# Access Compliance Report

## Public Rights-of-Way

### (Curb Ramps)

Intersection ID: 10029624	Main Street: KING_LOUIS_CT	Cross Street: N/A	Location: NE
ADA ID: AAF767D247B0	Ramp Type: PerpDiag	Initial Pass/Fail: Fail	Overall Compliance: No
Severity Score: 35			
Codes/Mitigation Info/Possible Solution		Field Measurements/Component Compliance

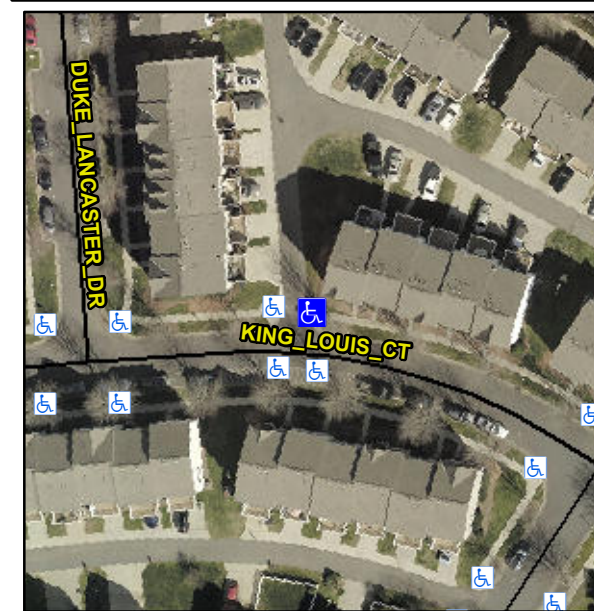
Compliance	Description	Data	Compliance	Description	Data
N/A	Ramp Length (in)	82.0	No	Ramp Slope (%)	13.6
No	Ramp Width (in)	45.0	No	Ramp XSlope (%)	2.1
N/A	Flare Type LT	N/A	N/A	Flare Type RT	N/A
N/A	Flare Slope LT (%)	N/A	N/A	Flare Slope RT (%)	N/A
N/A	Flare Traversable LT?	N/A	N/A	Flare Traversable RT?	N/A
N/A	Landing Length (in)	N/A	N/A	DWS Provided?	N/A
N/A	Landing Width (in)	N/A	N/A	DWS Contrast?	N/A
N/A	Landing Slope (%)	N/A	N/A	DWS Length (in)	N/A
N/A	Landing X Slope (%)	N/A	N/A	DWS Full Width?	N/A
N/A	Landing Curb? (Y/N)	N/A	N/A	DWS Offset (in)	N/A
N/A	Shared Landing?	N/A			
N/A	Gutter Ponding?	N/A	N/A	Gutter Slope (%)	N/A
N/A	Gutter Lip Ht (in)	N/A	N/A	Gutter X Slope (%)	N/A
N/A	Painted X Walk1?	No	N/A	Painted X Walk2?	No
	X Walk 1 Direction	To S		X Walk 2 Direction	To W
N/A	X Walk 1 Width (in)	N/A	N/A	X Walk 2 Width (in)	N/A
	X Walk 1 Slope (%)	1.7		X Walk 2 Slope (%)	0.4
	X Walk 1 X Slope (%)	3.1		X Walk 2 X Slope (%)	2.8

N/A	Ramp inside XWalk1?	N/A	N/A	Ramp inside XWalk2?	N/A
	Road Slope (%)	0.8	N/A	Clear Space?	N/A
	Road X Slope (%)	0.3	N/A	Clear Space to XWalk (in)	N/A
N/A	Any Obstructions?	N/A	N/A	Storm Grate/Utility Hazard?	N/A
	Obstruction Type			Storm Grate/Utility Type	
		N/A			N/A
			Yes	Surface Condition? (G/P)	Good

**Remove & Replace Curb Ramp With Two New Directional Ramps or Equivalent.**
